**EXTERNAL PEER REVIEW OF TWO DRAFT TECHNICAL
REPORTS FOR EPA'S MOTOR VEHICLE EMISSIONS
SIMULATOR (MOVES), VERSION: MOVES_CTI_NPRM**

**FINAL PEER REVIEW REPORT
January 7, 2020**

**COMMENTS RECEIVED FROM
MR. DANA LOWELL**

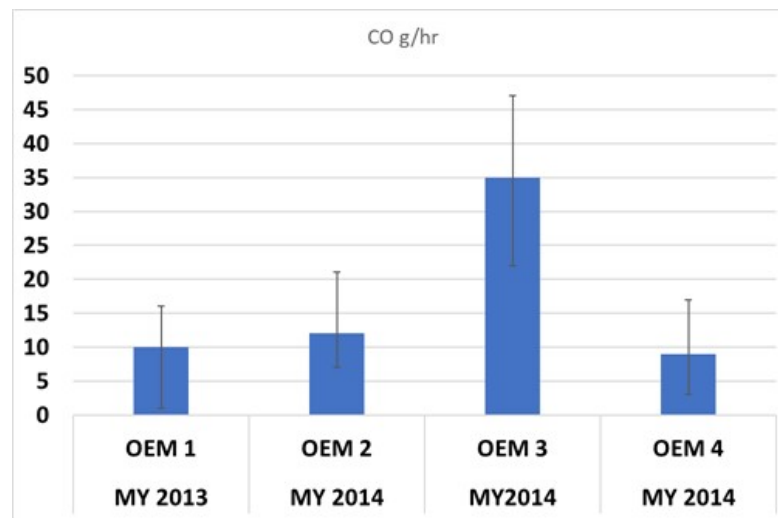
The reviewer is in agreement that the PM rates presented are similar to results observed during real-world studies. The DPF is highly efficient for most part of the vehicle operation that instantaneous PM measurements are subject to a lot of noise. Based on real-world emissions testing experience, the effect of passive regeneration is mostly observed during a steep hill climb operation, which would be characterized by speeds between 30-45 mph and close to full power. Based on the op-mode definition one would expect modes 28, 29, 30 and in some cases mode 38 and 39 to be characterized by highest PM emissions as a result of passive regeneration. The literature reference 157 is an excellent source of PM data for modern HHD

vehicles. An array of PM instruments was employed and instantaneous PM measurements using micro-soot sensor, Pegasor tailpipe sensor and a Horiba SPCS was performed. This data set would uniquely differ from HDIUT dataset due to the steep hill climb routes tested in Southern California at a vehicle weight of 69,000 lbs.

The trend of MHD vehicle PM emissions rate being higher than HHD could be attributed to a different type of DPF. MHD diesel engines in my opinion would be mainly dominated by Cummins ISB platforms and Ford Navistar 6-liter engine platforms. I believe there is significant difference in the DPF material used between the two OEMs and the type of regeneration they would be subject to. In the reviewer's experience, some MHD OEM use SiC substrate while some use the Corderite based substrate. Although both substrates provide excellent filtration efficiency, backpressure management dictates the frequency of regeneration between the two substrates. From my experience, SiC substrate requires more frequent regeneration than corderite and the consequent drop in filtration efficiency could be attributed to higher PM rates. Furthermore, the highly catalyzed corderite substrates could also be subject to extended passive regeneration due to conducive exhaust temperatures unlike in HHD applications. This could also lead to higher PM emissions rate.
